## Staff Report

To: BOZAR  
From: Jessie Earley, Town Planner III  
Meeting Date: DRC, May 12, 2025  
RE: 75 Pyramid Way, Secondary Review

**PROJECT TITLE:** Guidone (75 Pyramid Avenue)

**SUMMARY:** Consideration of the application of **Franklin D. Guidone and Elizabeth A. Guidone** to site a single-family residence and two cold accessory buildings to be located at 75 Pyramid Avenue, Lot T3, Slate River Subdivision in the R1F zone.

### 5/12 DRC: Revised Site Plan

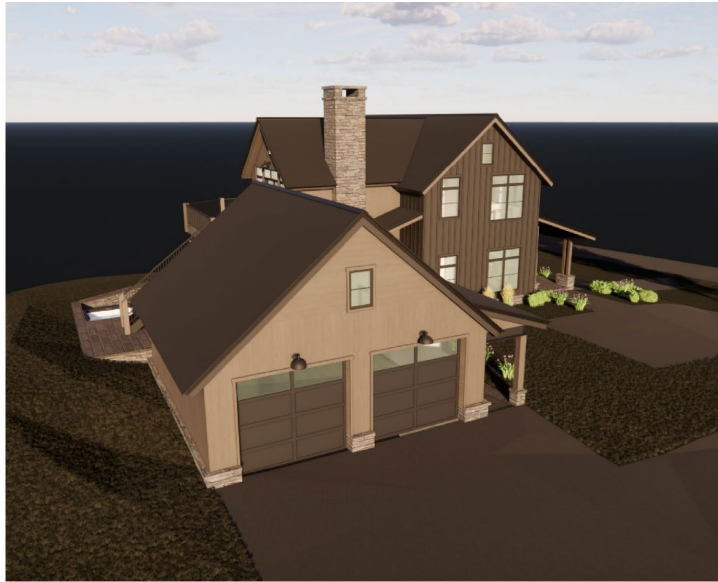
GL	Staff Analysis	DRC Recommendation
Topography	On the southeast corner of the lot, the grade is 8867', which steps up to 8879' on the northeast corner. Then, this transitions back down to 8876' to the west and down to 8871' on the southwest corner.	4/21 DRC: Members asked for information to be added to the plan. The applicant confirmed heights are met, but the information is still needed on the elevations/sections.

2.8 Drainage	<p>Drainage information has not been provided. Drainage arrows for the site must be shown.</p> <p><b>A drainage plan will be required. Confirmation of if a dewatering well will be required, is needed.</b></p> <p><b>During construction, stormwater management and erosion control will be required in an overall construction management plan.</b></p>	
Easements	<p>There is a 10' utility easement for the west side of the lot. This must be included on the site plan.</p> <p><b>There is an irrigation line on the south side of the south property line within the ROW. The propane tank must be shown at least 5' away from this.</b></p>

2.19 New trees	<p>There are two aspen trees on the south side of the property on the east and two spruce trees on the south side on the west. This appears to meet the intents of GL 2.19 a as it requires two trees.</p> <p>There is a cluster of aspen proposed on the east and also on the north. This appears to meet the intents of GL 2.19 and 4.28 are met.</p> <p><b>The trees on the south property line</b></p>

<b>must be shifted to be fully within private property. The trees proposed on the northwest corner must be removed from the utility easement.</b>	
2.16 a./ 2.20 Native plantings	Ground cover is not noted. Native materials are encouraged by the GL.

2.16 e Pervious materials 2.28 e & f Parking substrate	<b>Walkway (272sf) and parking/drive areas (618 + 366 sf) are noted as gravel. The area on the south was decreased to accommodate one car, as the code requires.</b>  The patio on the north and east and walkway between buildings (1436.13 sf) is noted as pervious pavers. This area is a large amount of hardscape. Discussion is encouraged. It is appreciated that this material is pervious.	4/21 DRC: Members encouraged revisions to the walkway on the southwest corner to ensure that this is seen as the front.  Members discussed the amount of hardscape and said that this will likely be discussed at the full Board meeting.

**4/21 DRC: West perspective**

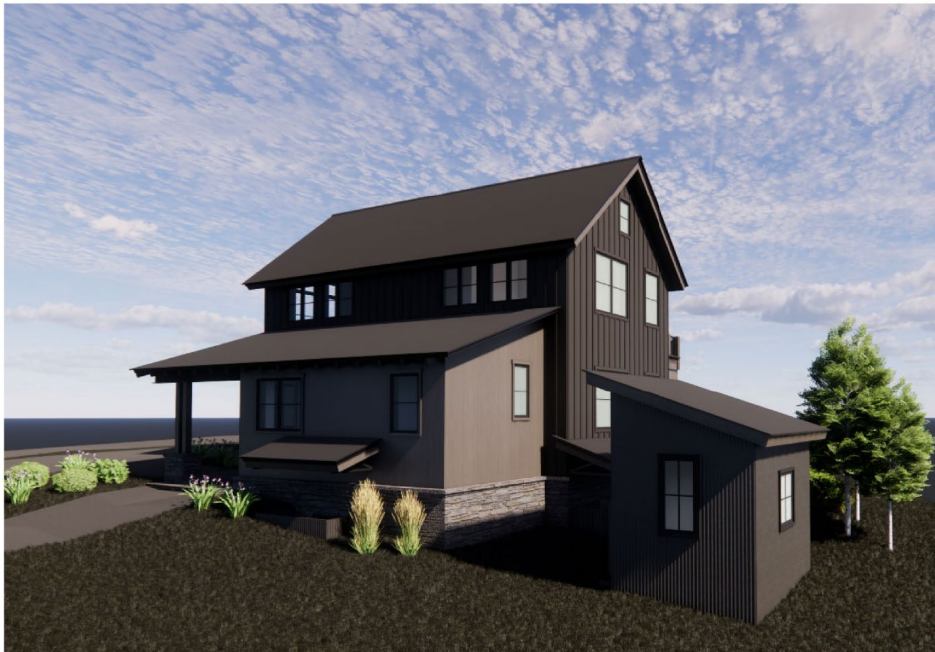
GL	Staff Analysis	DRC Recommendation
4.71 Chimney	The chimney appears large and oversized as seen from the west. The top is 3'4", as seen from the north and east. Then it steps up to 7'1" at the base. Discussion is encouraged. <b>The applicant has noted that this is what is required by code.</b>	4/21 DRC: Members voiced concerns regarding the chimney as proposed.

West – Chimney, it was suggested to decrease the width on the exterior and increase it on the interior. Applicant will work on this.

- The fireplace and chimney have been reduced to minimum allowable dimensions for a Rumford 1500 unit.
- The southern window well has moved to the East side of the primary. This window well move allowed the primary residence to move 2' South on the site.
- The steel beams have been changed to wood beams.
- The horizontal siding has been removed at the gable ends sided with Board & Batten.
- 2" trim added under transom windows.

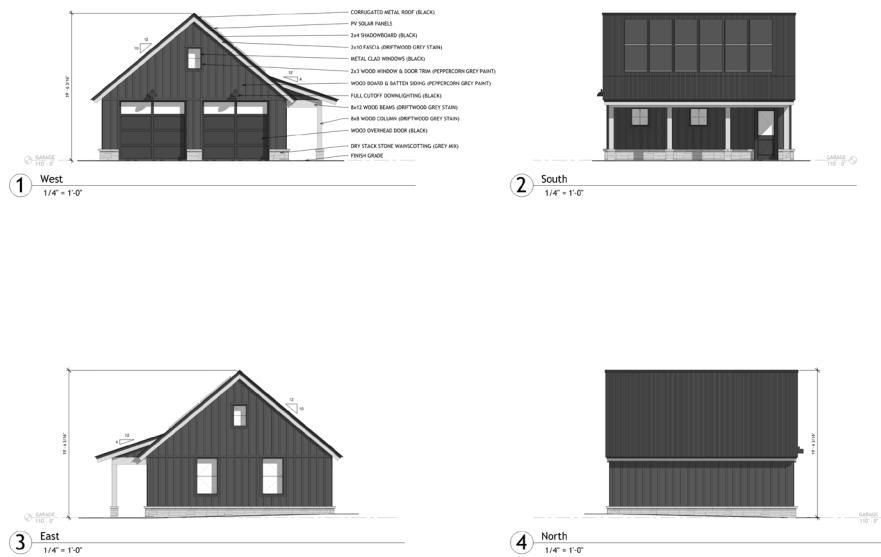
4.75 e /4.80 a foundation treatment	The rock varies in height and does exceed 18" in certain areas. This must be reduced. The area on the south is highly visible.  <b>Discussion came up about Treasury Hill and the Heights, there has been a flexibility allowed for this zone district (R1B) due to existing materials and other features. Photos may be provided by the applicant of this area. However, this is a new zone R1F and discussion is needed to determine if this is appropriate. Staff suggests that this is incongruent on the street side (south) elevation.</b>	4/21 DRC: full Board discussion

### 5/12 DRC: Revised Elevations

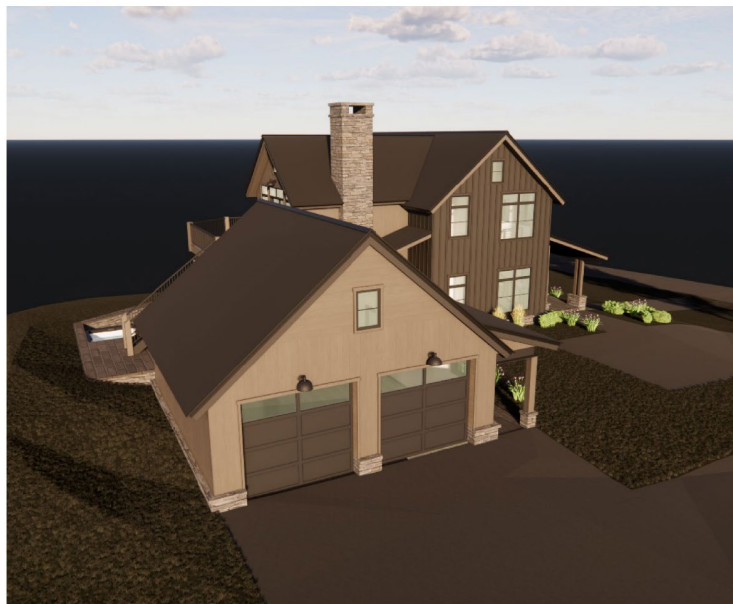
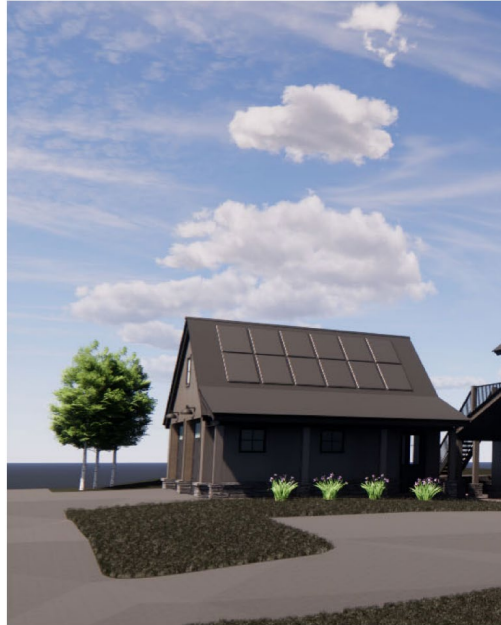
**Accessory building mass/scale/form and placement (garage):** Refer to GL 4.84-4.86, 4.89;  
The proposed north accessory building is an 24'x24' gable module. The main module has a 10:12 pitch with a 4:12 small shed porch roof on the south. This must be a cold building due to the size, as proposed.

AB (garage): Remove steel beam. Otherwise overall support.

4.75 e Metal materials	The beam on the front porch was revised to wood to better meet intents of the GL.  The metal braces and post tops are a revision to the original approval and are consistent with this GL.	4/21 DRC: Revise from metal, as it makes the contemporary building inappropriately contemporary.  Support
4.82 Roofing	The corrugated metal (black) roof is supported.	Support
4.83 Porch railing	Railings appear to meet the intents of the GL, but materials and sizing must be confirmed to ensure this.	Support

### 4/21 and 5/12 DRC elevations

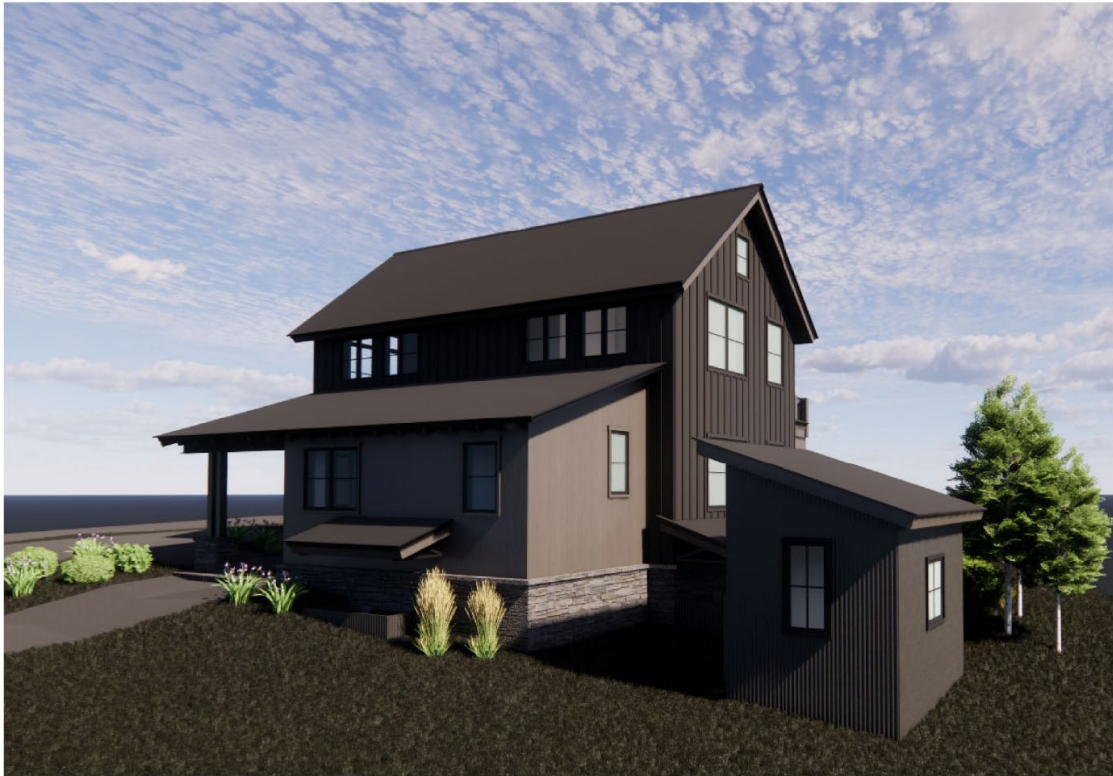
The proposed south accessory building is a 8'x12' simple shed building. The main module has a 4:12 pitch. Confirmation is needed if this will be a heated structure.

AB (shed): the heat pump units may need to be raised, but overall support as proposed.
